Subject: Davis-Besse Nuclear Power Station, Unit Number 1
Supplemental Information Regarding License Amendment Application to Revise
Technical Specification (TS) 3/4.5.2, Emergency Core Cooling Systems – ECCS
Subsystems – $T_{avg} \geq 280^{\circ}\text{F}$
(License Amendment Request No. 03-0008; TAC No. MB8953)

**DAVIS-BESSE NUCLEAR POWER STATION, UNIT NUMBER 1 (DBNPS)
LICENSE AMENDMENT APPLICATION TO REVISE TECHNICAL SPECIFICATION
(TS) 3/4.5.2, EMERGENCY CORE COOLING SYSTEMS –
ECCS SUBSYSTEMS – $T_{avg} \geq 280^{\circ}\text{F}$
(LICENSE AMENDMENT REQUEST NO. 03-0008)**

**COMPLETION OF RESPONSES TO NRC REQUESTS FOR ADDITIONAL
INFORMATION**

Figure 1. Full Power, High Decay Heat Post LOCA Representative Pressure-Time Histories

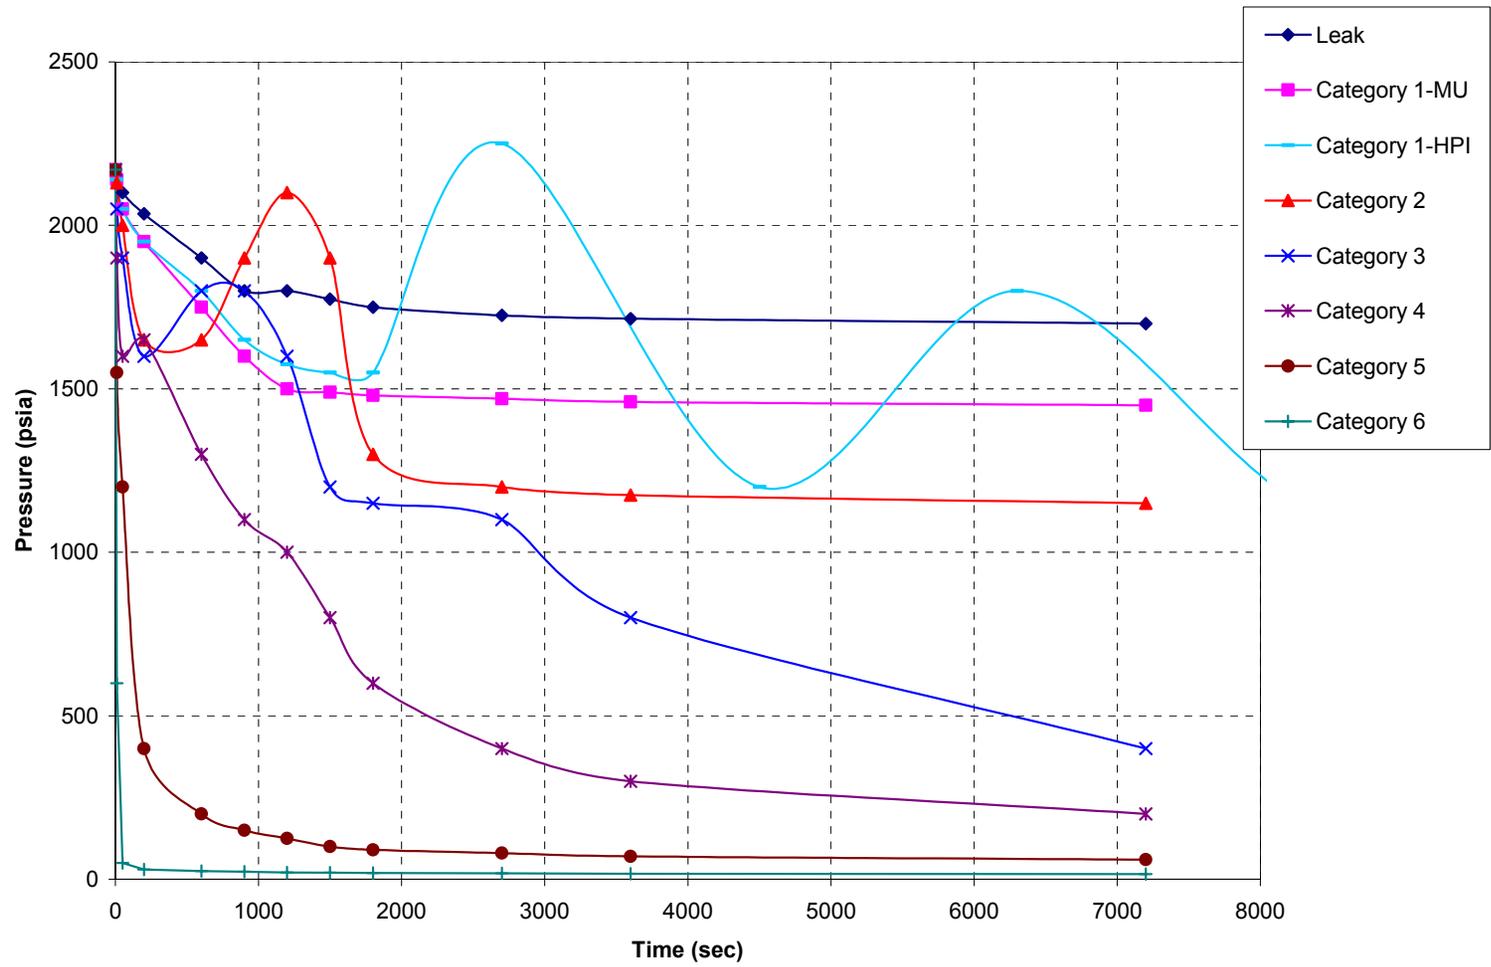
43. Provide docketed copy of the RCS pressure/time histories (full power as well as Mode 3) as supplied by FANP.

With these actions, the RCS remains in forced or natural circulation and the operators can use the steam generators to depressurize the system during the longer term phase of the event. The short term pressure response is shown in Figure 1 for leaks from full power initial conditions with high core decay heat levels.

If the MU pump flow is not included, the HPI pumps would not provide sufficient ECCS injection at the higher RCS pressures to match the break flow. The system inventory loss would cause natural circulation to be interrupted. This interruption in flow would result in initiation of core boiling and RCS repressurization above the HPI shutoff head. When the RCS pressure is above the HPI shutoff head, the RCS liquid inventory decreases due to the break flow. The RCS inventory will cause the RCS levels to decrease. When the primary levels descend into SG tube bundle below the AFW injection location, a high-elevation boiler-condenser mode (BCM) of heat transfer is established in the SG. The SG heat removal would decrease RCS pressure well below the HPI shutoff head. The HPI flow would be reestablished and it would exceed the break flow for the smallest break sizes in this category. The HPI flow would refill the RCS above the AFW injection location and the SG heat transfer would be interrupted. The RCS would repressurize again above the HPI shutoff head and the cycle would be repeated unless natural circulation could be regained. The RCS pressure could cyclically oscillate between the secondary side pressure and 1800 to 1900 psia for the smaller breaks in this category. These oscillations could last for days or weeks with only a slight decrease in the peak pressure as the core decay heat rate decreased. Figure 1 shows this response labeled as Category 1-HPI.

Once natural circulation is lost, it is difficult to refill the RCS and reestablish single-phase natural circulation in at least one loop with flow from only the HPI pumps. If the MU pumps are available or the PORV is opened, the RCS can be refilled. Once refilled, the SG cooldown allows the RCS to be cooled to the conditions at which the LPI system can be initiated. Therefore, credit for flow from the makeup pumps is key in the response for Category 1. The RCS pressure for a Category 1 break with flow included from the MU pumps is shown as Category 1-MU in Figure 1.

These moderate break sizes limit the RCS depressurization rate shown in Figure 1. Generally, it takes 25 to 60 minutes (depending on break size, decay heat power, and steam generator heat removal) for these break sizes to depressurize the RCS to the CFT pressure. During this time period, the core decay heat boils off the HPI flow that reaches the core and some of the RCS liquid inventory that drains into the reactor vessel. The continuous HPI flow delivery to the vessel is most critical for these break sizes, because the RCS liquid inventory available to augment the ECCS is only capable of providing 5 to 10 minutes of core boiloff before the core uncovers.

The AFW fill logic and AFW flow rate are less important on these transients because of the larger break size. Nonetheless, higher AFW flow rates can be beneficial in accelerating the RCS depressurization rate, holding up slightly more liquid in the hot leg and steam generator tubes, and reducing the steam generator reverse heat transfer. Figure 1 shows the characteristic pressure response for the Category 4 break sizes.

Break sizes greater than 0.25 ft² (but less than 0.75 ft², the upper range of SBLOCAs) are sufficiently large to depressurize the RCS to approximately that of the containment pressure as shown in Figure 1. These breaks are not large enough to reverse core flow, which would cause the cladding to exceed the critical heat flux upon break initiation. The core is shut down via control rods and cooled during the blowdown transient, which maintains a two-phase mixture that keeps the fuel pin cladding within a few degrees of saturation so long as the mixture level remains above the top of the core. During the rapid depressurization to the CFT pressure, some of these break sizes may cause some core uncovering and cladding heatup. For breaks with the RC pumps running for the first two minutes after LSCM, this situation is exacerbated, because the pumps push additional ECCS and RCS liquid to the break site. The duration of the uncovering is short since CFT flow quickly refills the core and quenches the clad temperature. Depressurization to the LPI initiation pressure will occur within the first two to ten minutes post LOCA, therefore HPI inflow during these first several minutes is of little consequence for core cooling prior to the time of core refill so long as the LPI liquid reaches the vessel. After the CFTs are empty and the core is refilled, however, LPI and HPI flow provide both diversity of makeup injection sites and more than sufficient

Break sizes greater than 0.75 ft² (up to a full double-ended break of any RCS pipe) are considered large break LOCAs. These break sizes are of sufficient size to cause the cladding to exceed the critical heat flux upon break initiation. If the break is on the cold leg side of the core, the core flow may reverse during the blowdown phase. Core cooling during the blowdown and refill phases of the LOCA is by high velocity steam or steam plus liquid droplets. The final cladding quench occurs when the core is reflooded by CFT and LPI flow within minutes after break opening. The pressure response for these breaks is shown in Figure 1.
